WEST SUSSEX COUNTY COUNCIL CONSULTATION

TO:	Arun District Council FAO: Mr. S. Davis
FROM:	WSCC – Highway Authority
DATE:	10 September 2026
LOCATION:	Land West of Lidsey Road (A29) Lidsey PO22 9RG
SUBJECT:	AL/27/26/RES Approval of reserved matters following outline consent AL/70/23/OUT for the development of 155 No residential dwellings with associated parking, landscaping, open space (including play areas), infrastructure, works and demolition of existing structures, This application is a Departure from the Development Plan and is in CIL Zone 3 and is CIL Liable as new dwellings. Amendments in response to Highway and Landscape Comments - see covering letter.
DATE OF SITE VISIT:	n/a (desktop study undertaken for purposes of this RES planning application)
RECOMMENDATION:	Advice

This is the **updated second** WSCC Highways response to the above planning application seeking approval of reserved matters following outline consent AL/70/23/OUT for the development of 155 No residential dwellings with associated parking, landscaping, open space (including play areas), infrastructure, works and demolition of existing structures.

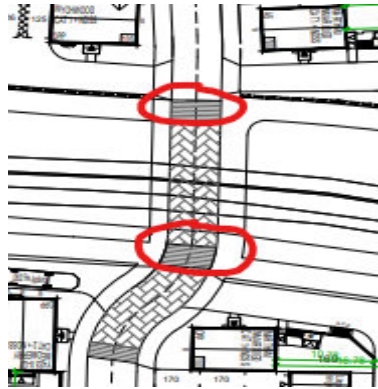
- Shared surface areas should be shown being constructed in contrasting material (blockwork). *This is now shown. However, for the section of shared surface/private access driveway that start adjacent to plots 221, 225 and 236, the footway should be terminated just south of the raised feature that delineates the start of the different road surface. This should be picked up at detailed design stage.*
- The driveway widths should be shown. For single width, WSCC recommend 3.0m between walls/obstructions – for double – 6.0m.
- Tactile paving isn't shown at junctions and adjacent to crossings. This will need to be picked-up at detailed design and/or S38 stage. *A number of junctions are now shown with tactile paving. The Highway Authority recommends that further tactile paving is considered at the following locations (again, can be picked up at detailed design stage):*

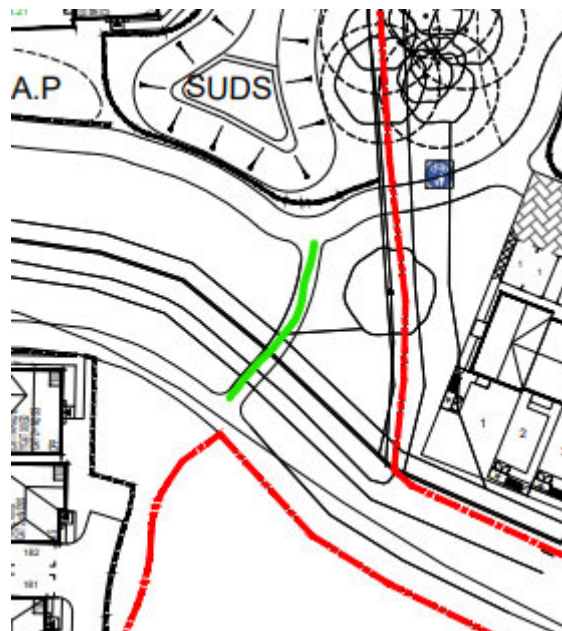
- Service margins will be required around roads where the applicant intends to offer them for adoption through a S38 Agreement. Standard dimension is normally 2.0m - anything less may prevent adoption. *The latest plan shows service margins at various locations and at varying widths. As stated previously, anything less than 2.0m might prevent adoption.*
- Is pedestrian and cycle prioritisation proposed here across the carriageway?:-

Based on the drawing submitted, priority for non-motorised users is not provided at the above locations, although the raised carriageway at this location has been extended and amended which would highlight that pedestrian and cycle crossings are being provided at this location.

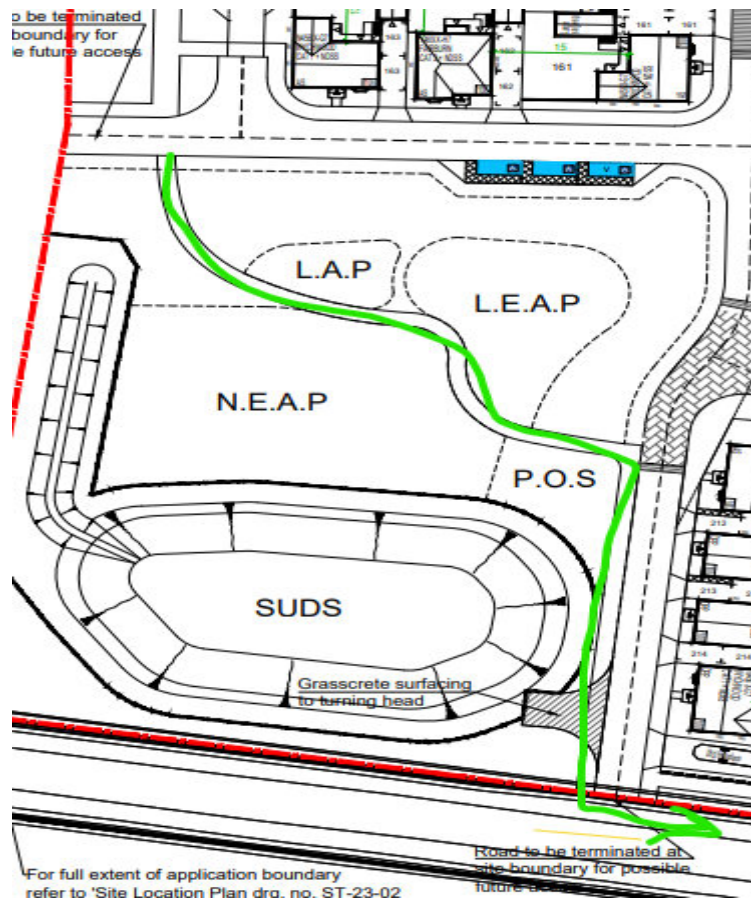
- Recommend that this path be widened to provide shared foot and cycle use:-

This is now shown.
